SUBJECT: Responds to NRC 900919 request for addl info re util rept,
NTH-TR-01, "RETRAN Model Clarification - Decrease in Heat
Removal by Secondary Sys."

L-91-108

Re: Response to Request for Additional Information
Related to Topical Report NTH-TR-01, RETRAN Model
Qualification - St. Lucie Plant Unit Nos. 1 and 2
and Turkey Point Plant Unit Nos. 3 and 4 (TAC Nos. 75082,
75083, 75084 and 75085)

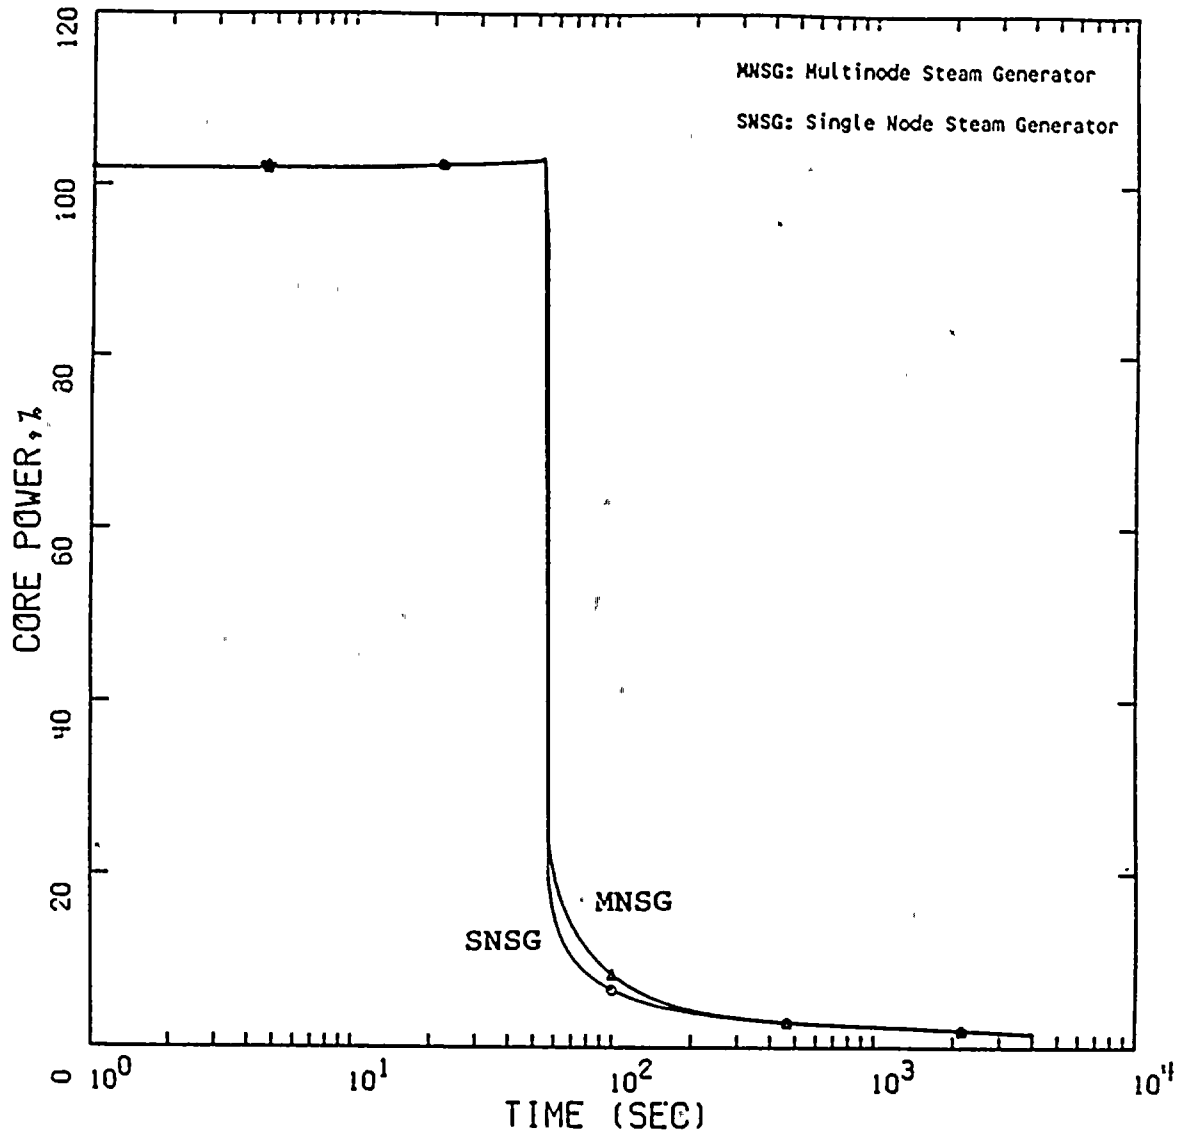
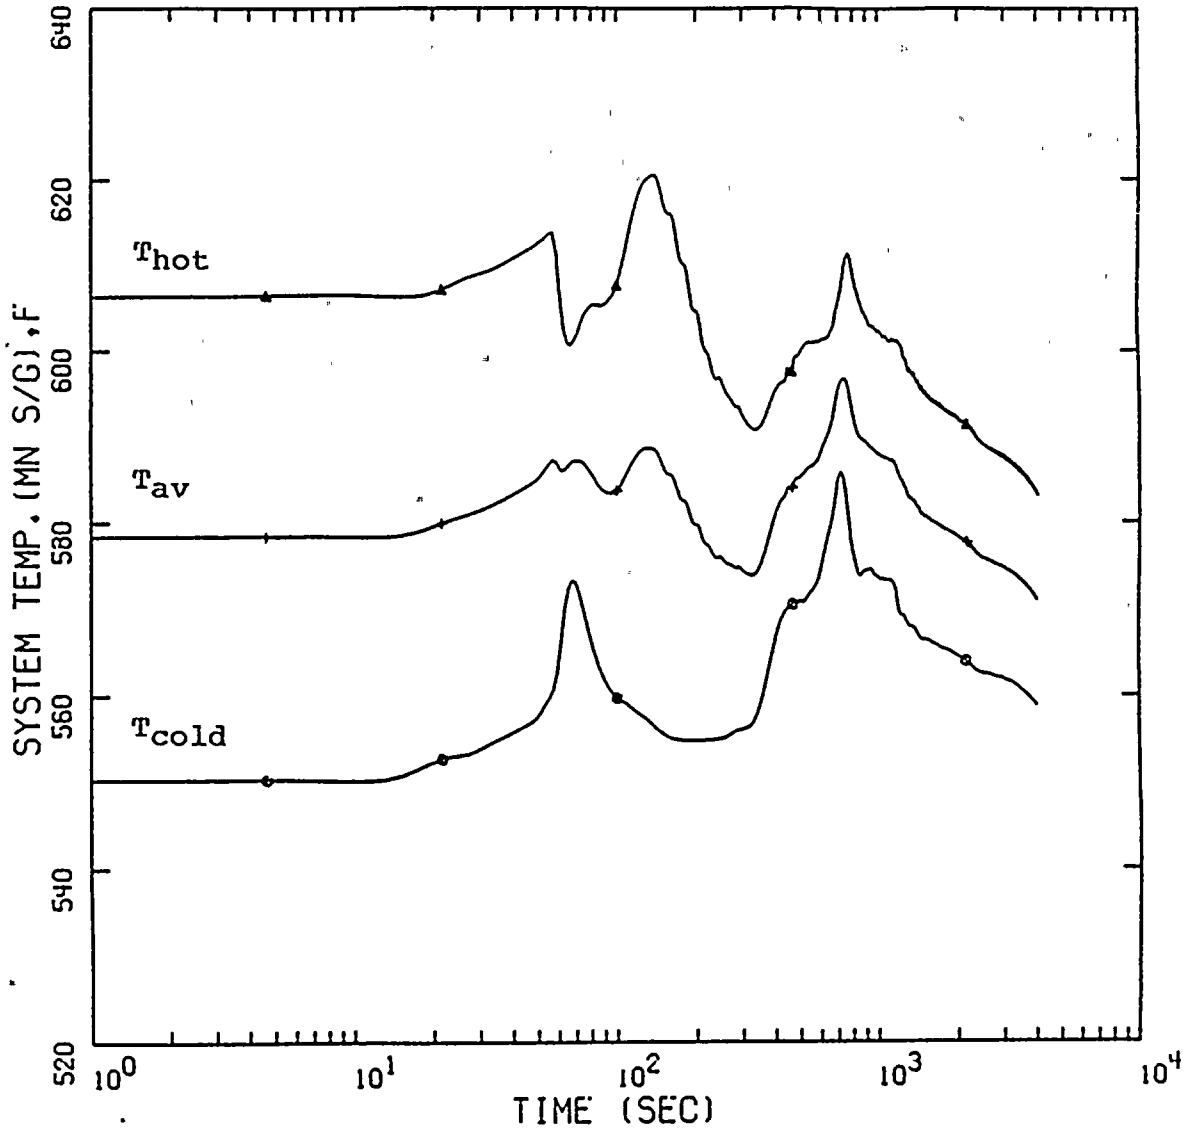
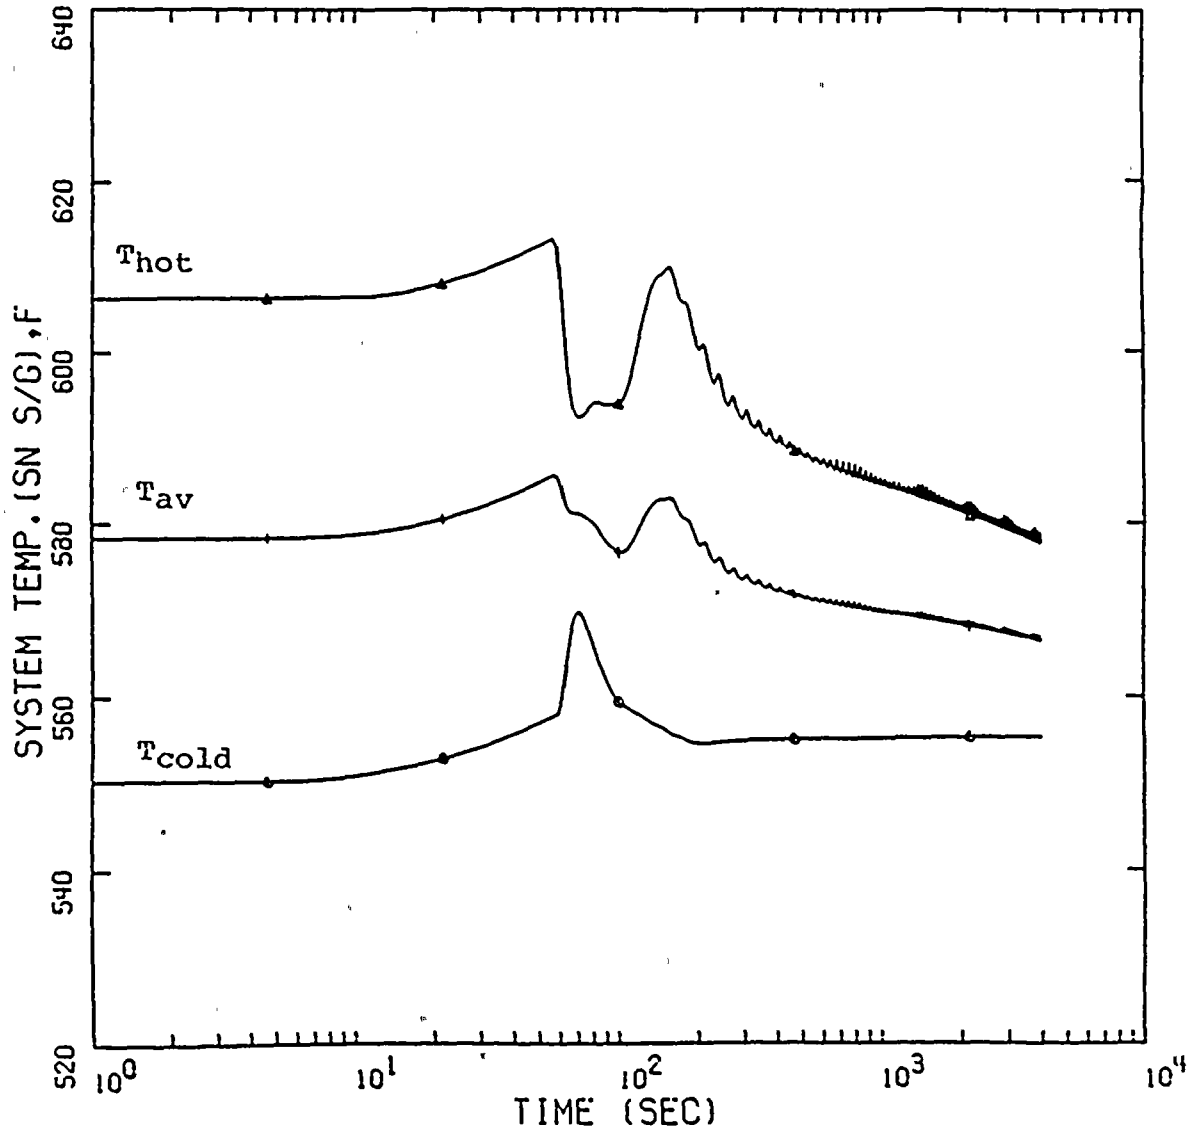
QUESTION: Demonstrate, by steam generator nodalization parametric studies, that the chosen nodalization for each vendor's plant produces conservative results compared to other nodalizations.

COMPARISON OF MULTINODE AND SINGLE-NODE STEAM GENERATOR RESULTS FOR THE TURKEY POINT LOSS OF AC POWER TRANSIENT

The attached plots compare the RETRAN results of the Turkey Point Loss of AC Power Transient with single-node and multinode steam generator models. The multinode steam generator analysis is the one reported in the Reference Submittal (Section 4.2.3.6). The single-node analysis is based on a model in which the initial steam generator inventory has been adjusted to match the time of the low level trip in the multinode analysis. The time of low level trip in the single-node analysis had to be approximated with a vendor provided trip-equivalent steam generator inventory.

FIGURE 1. PRESSURIZER PRESSURE
MSSV SENSITIVITY

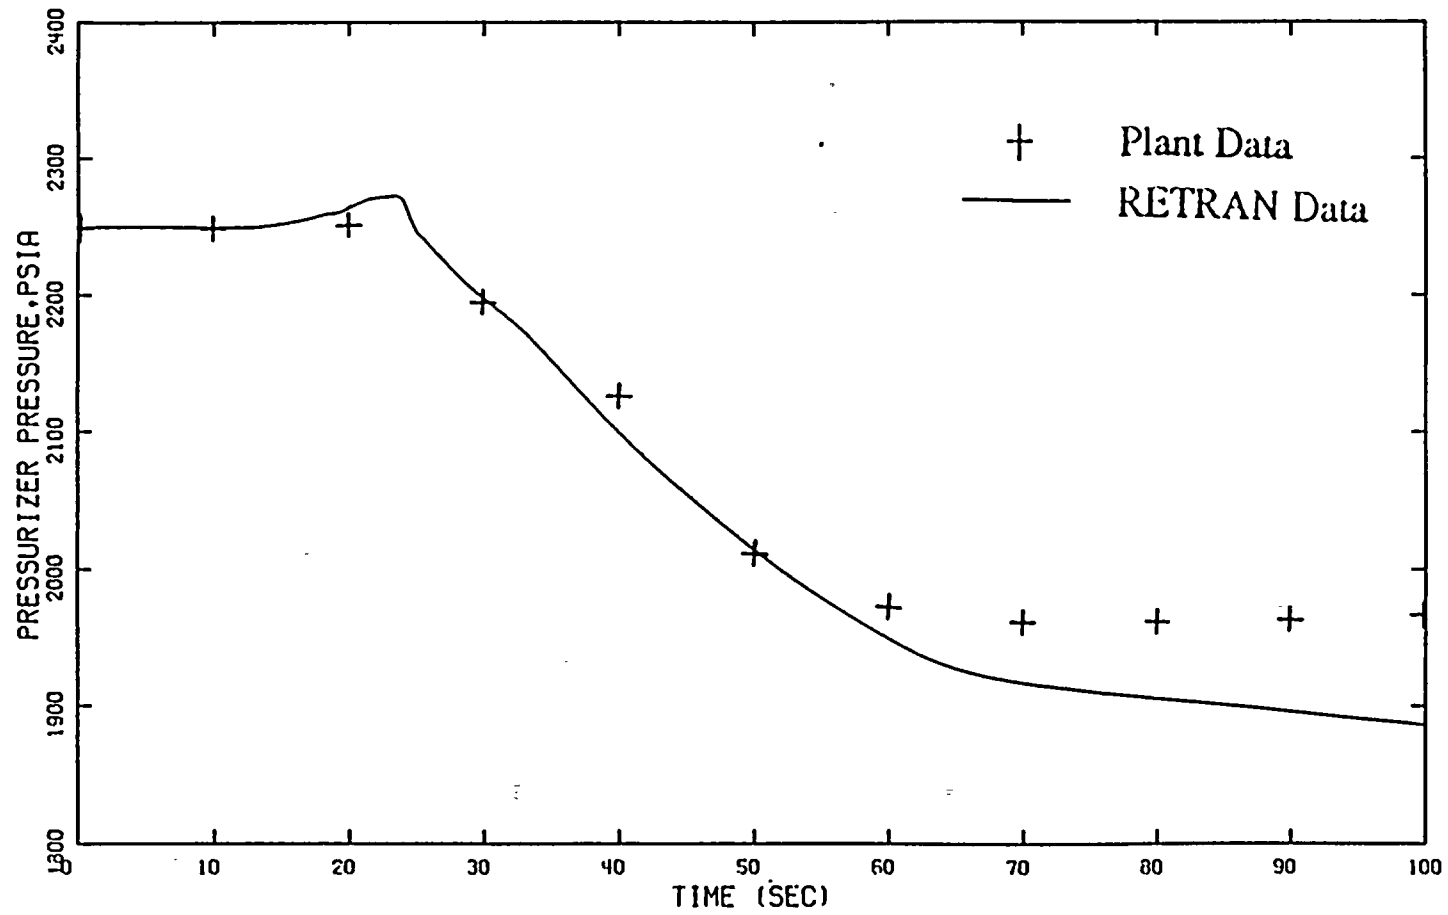
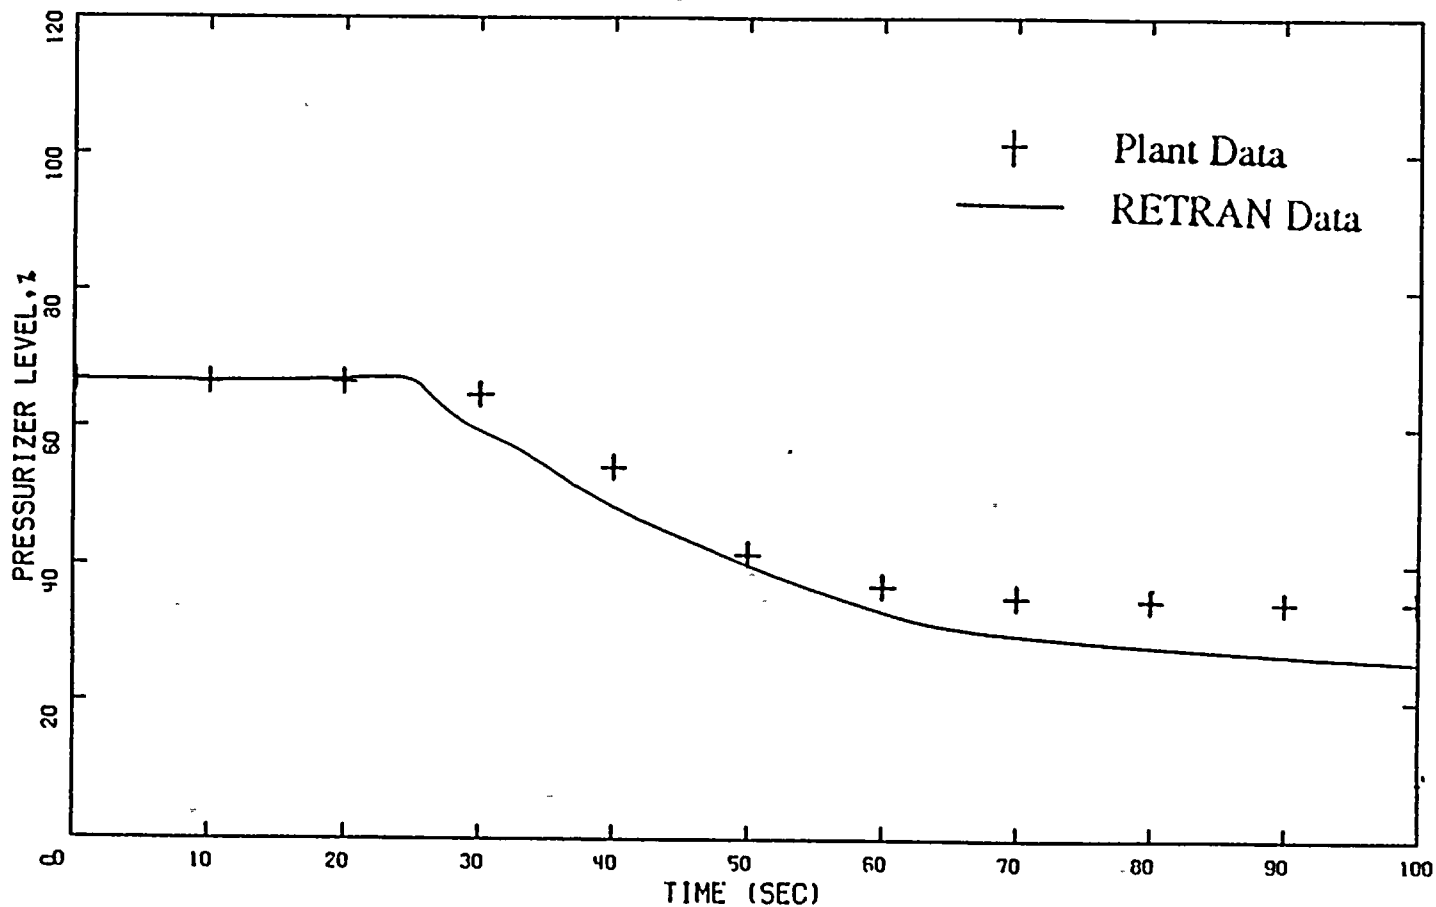
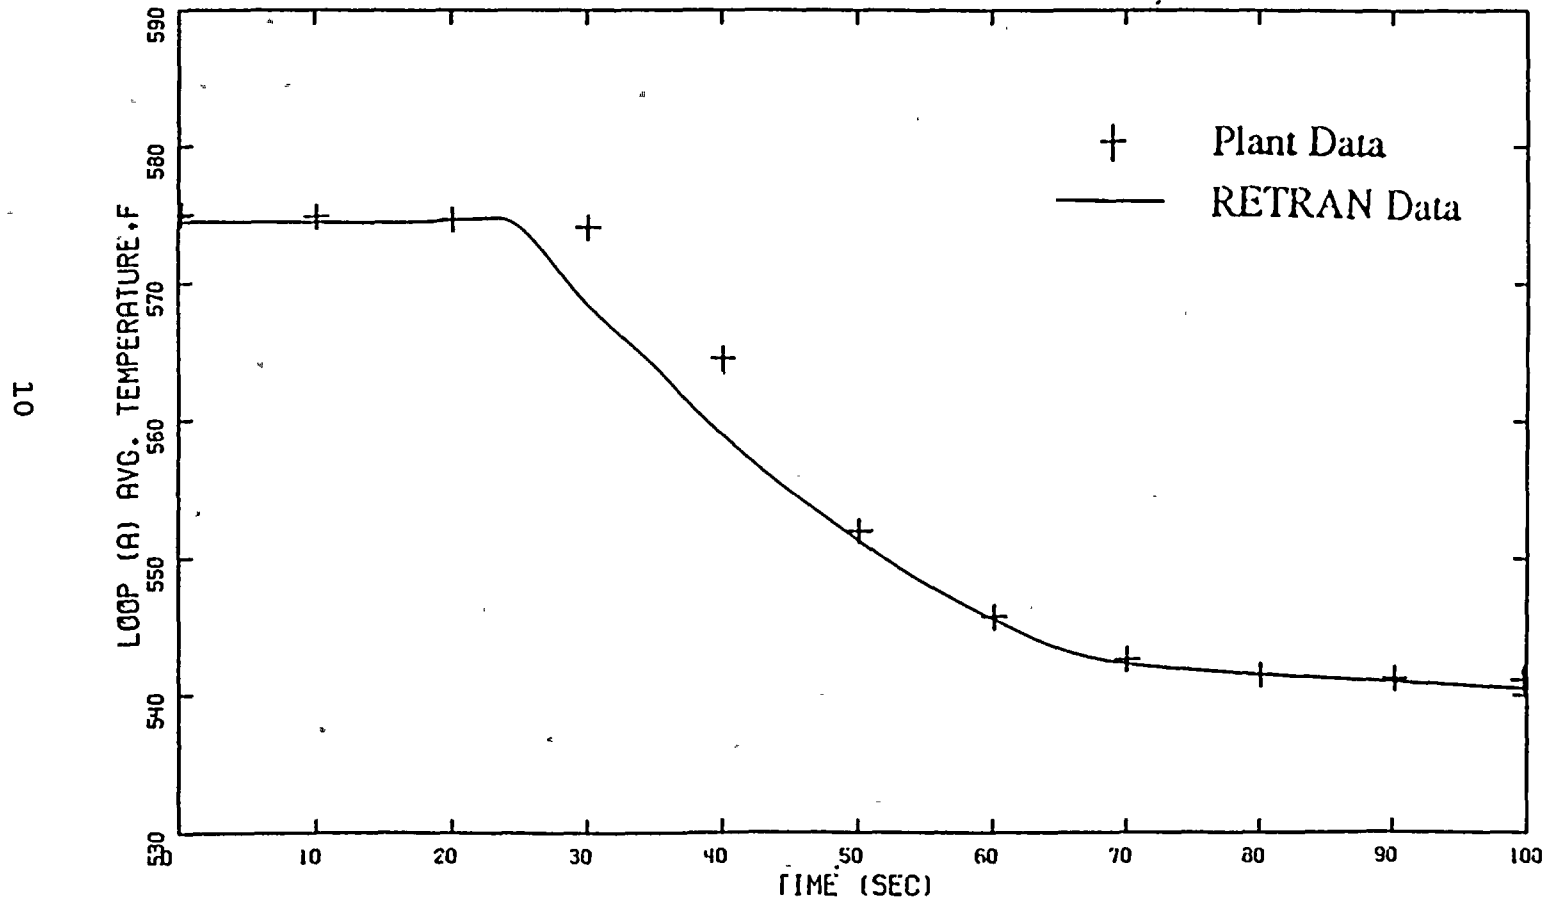
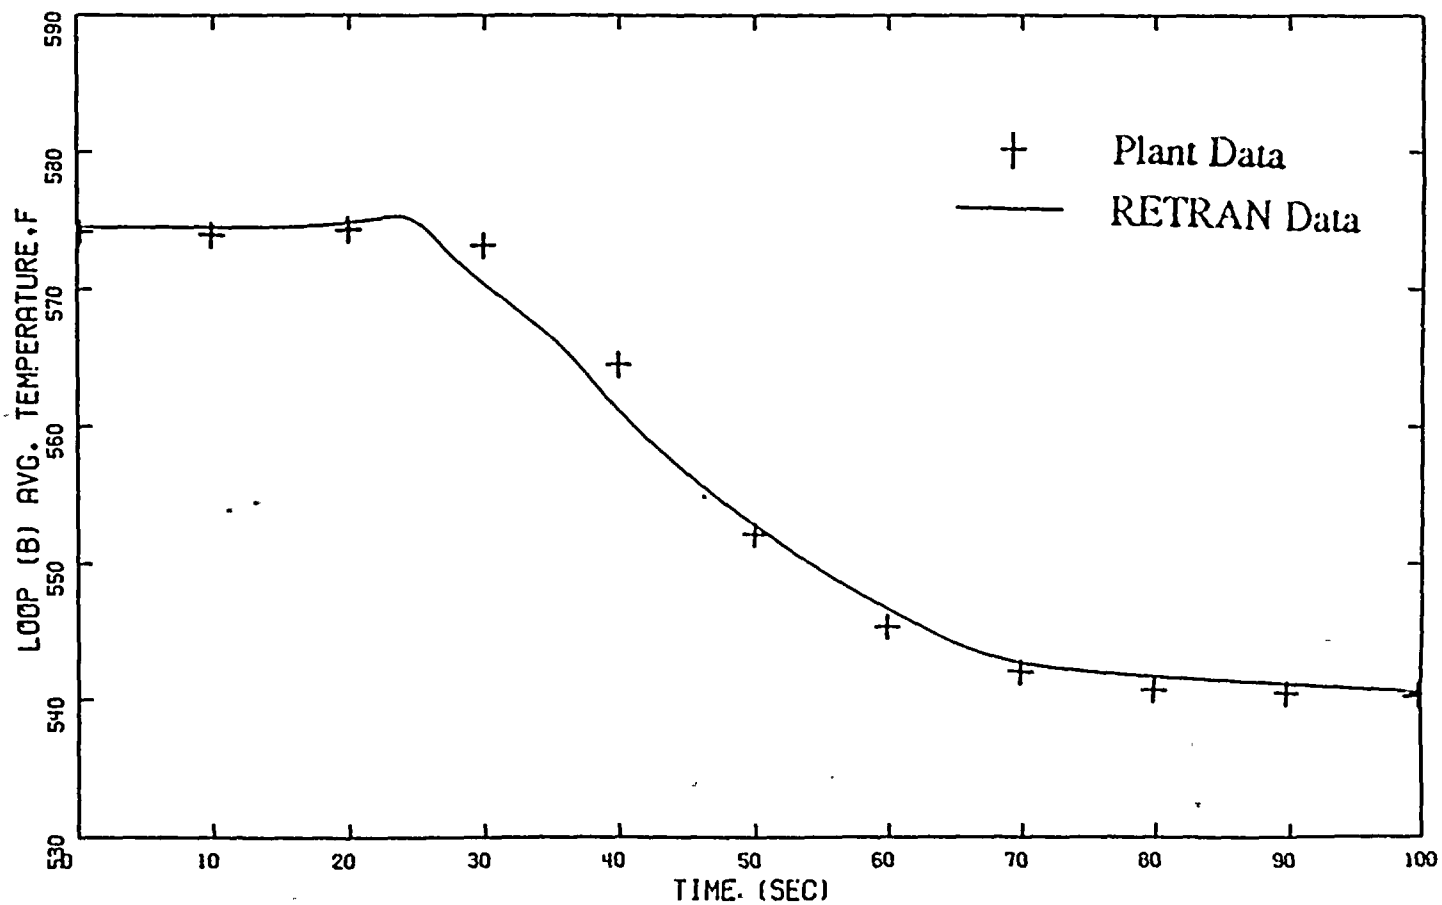
QUESTION: Explain how the MSSV component input was determined. Provide any physical basis for the assumptions made in the sensitivity study with respect to the flowrate and the number of valves operating. Did FPL change nodalization as a result of observing that separately modeling the MSSV's lead to better comparison with measured data? Provide comparisons of other computed parameters on the primary side with measured data after the change in MSSV modeling. Explain the differences between predicted and measured steam generator pressure and level trends after 40 seconds.

Figures 1 through 4 show the requested comparisons between plant data and the RETRAN predictions for primary side parameters.
